Western Sub Regional RTEP: AEP Supplemental Projects

July 18, 2025

Changes to the Existing Supplemental Projects

AEP Transmission Zone: Supplemental S2167 Scope Change

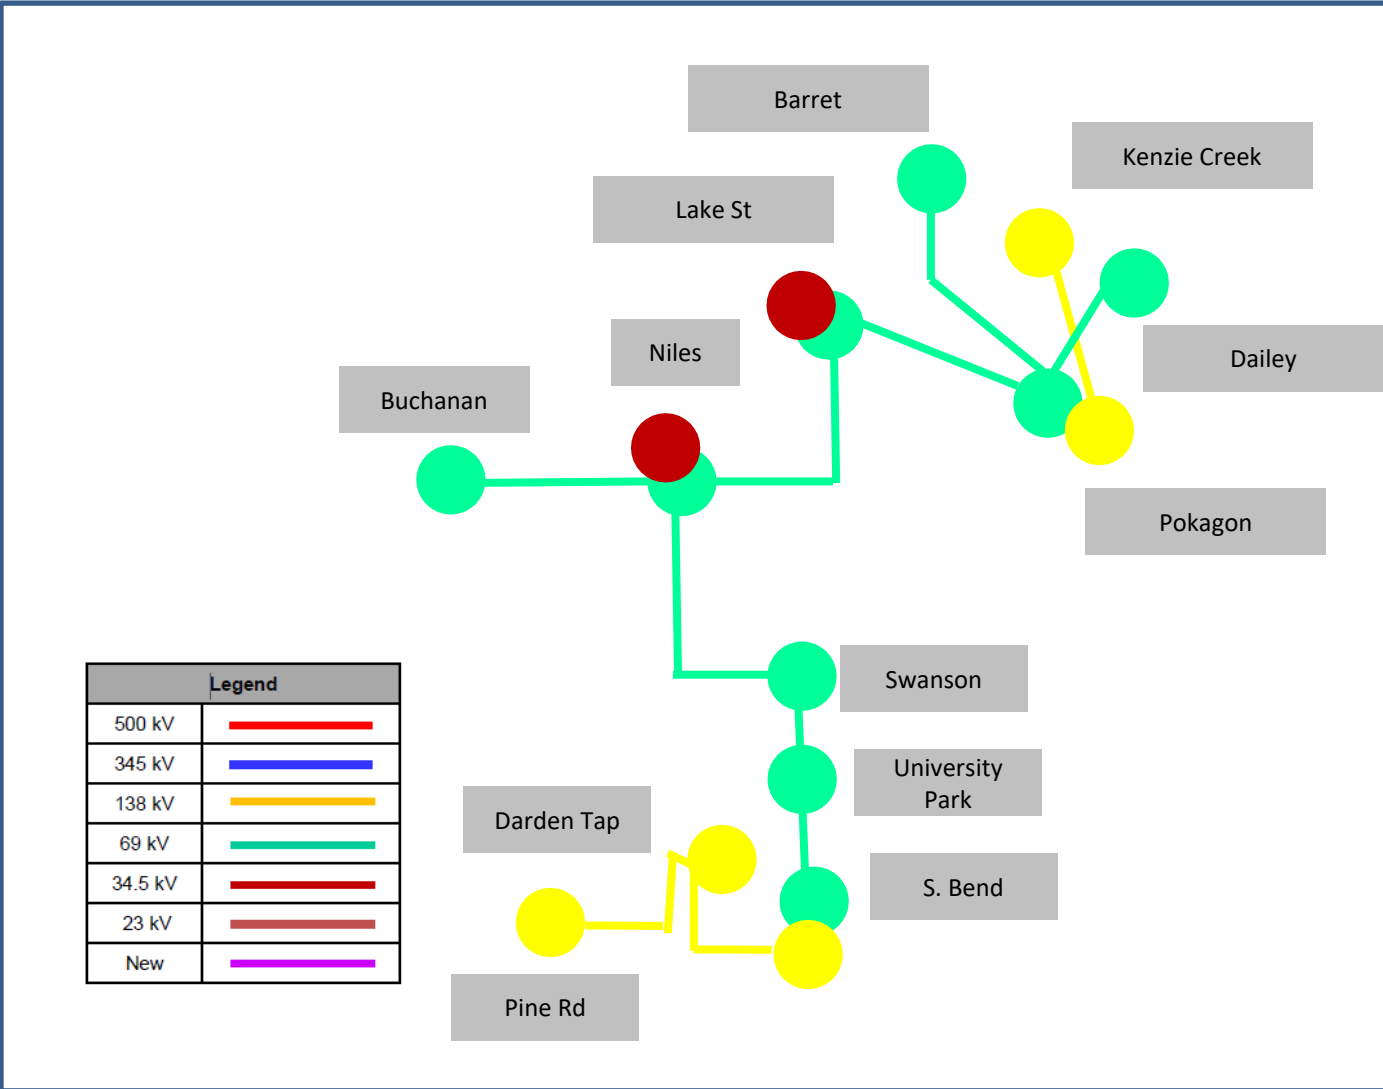
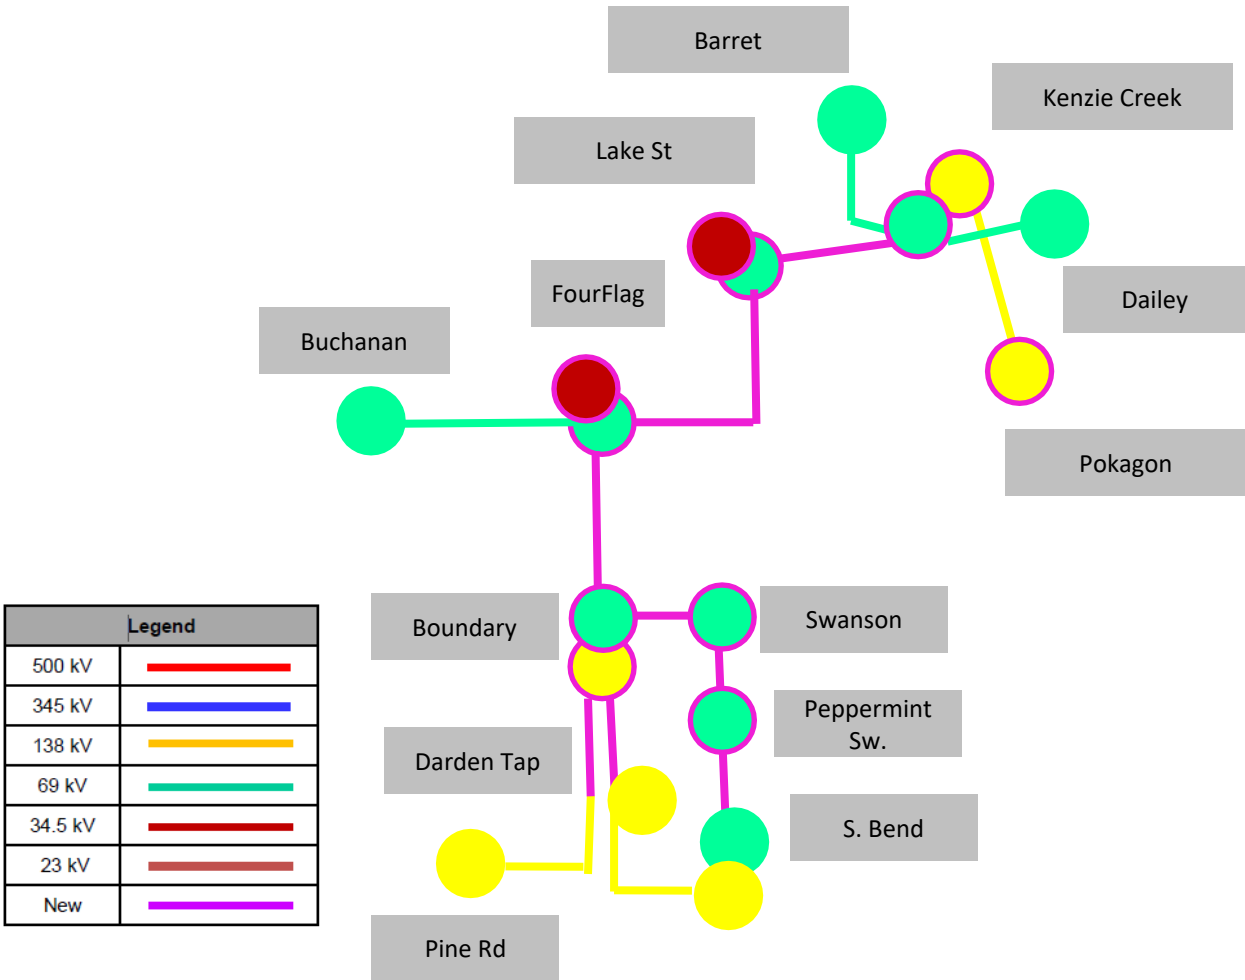
During detailed engineering and design for the proposed work at Niles station, it was determined that the proposed station work could not be completed as proposed without the use of multiple mobiles or skids and would leave all customers served from the station on long radials for extended periods of time under the various required outages. The only vehicle access to the station is surrounded by water on both sides, is prone to flooding, and can be extremely dangerous in adverse weather conditions. At Swanson station, Distribution has requested the station be rebuilt in the clear to due to outage risks associated with aging asset conditions installed in the 1950s and 1970s. Swanson has 34.6MVA of load that is non-recoverable and non-transferrable to neighboring stations in the event of equipment loss or for outage recovery. This update is provided to change the scope of Niles station to rebuild in the clear as FourFlag station and to rebuild Swanson on existing property at the site in the clear.

At Niles station, replace 69kV breakers “B” and “A”. Replace XFR 2 and the breaker toward the City of Niles. **Retire Niles station.**

Build the new FourFlag station to replace Niles consisting of 5 69kV circuit breakers configured in a ring bus. Install a 14.4 MVAR cap bank. Install a new 69/34.5kV transformer with high side circuit switcher and 2 new 34.5kV breakers toward the City of Niles and Bertrand. Install distribution equipment.

Route the Mayflower 69kV, Lake Street 69kV, South Bend 69kV, and City of Niles 34.5kV lines into FourFlag station.

Rebuild the Pokagon – Niles 69kV line as the ~9.3 mile Kenzie – Niles **FourFlag** 69kV line.

Rebuild the ~11.8 mile South Bend – Niles 69kV line as the South Bend – Boundary – Niles **FourFlag** 69kV line

Install a 69kV bus tie CB at Swanson station to separate the 4 Moabs in series.
Rebuild Swanson in the clear. Cost: ~~\$2.1M~~ **\$2.6M**

Estimated Cost: ~~\$6.2M~~ \$1.7M

Estimated Cost: ~~\$101.3M~~ **\$125.8M**

Projected In-Service: ~~06/01/2022~~ **3/13/2026**
